Preliminary Information

PIT5505A Rattle Noise Diagnostics with LWN 2.8L Diesel

This PI was superseded to update Model Years. Please discard PIT5505.

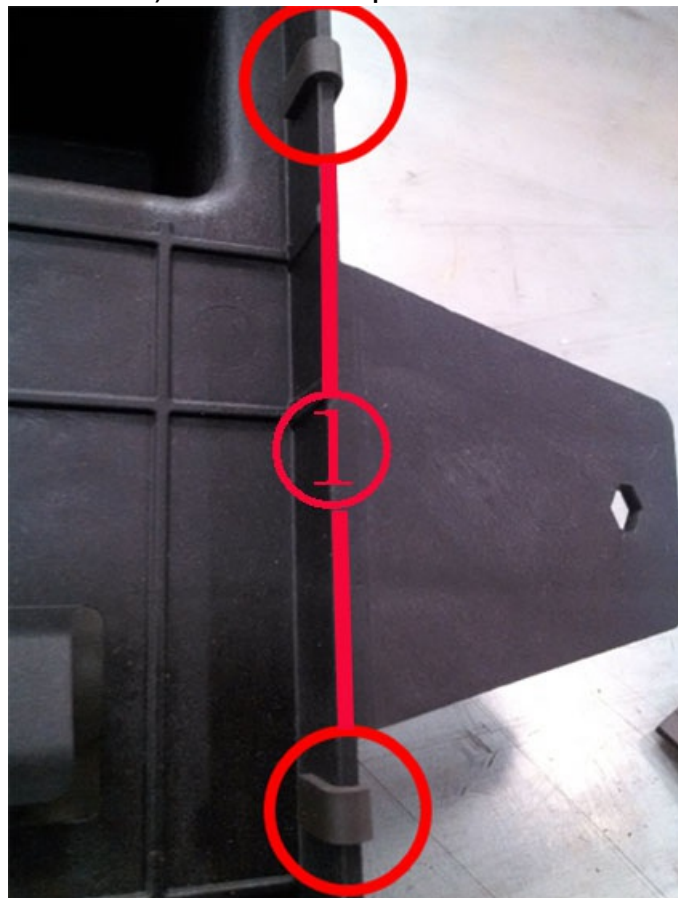
1.) The ECM may be loose in the mounting bracket. If you can move the ECM in the bracket remove it from the mount and apply 2 foam strips , 2mm thick, 20mm by 15mm to the body of the bracket and reinstall the ECM. (Recommend Walco 215 or 3M 4696 adhesive backed foam.) Place the foam strips as shown below.
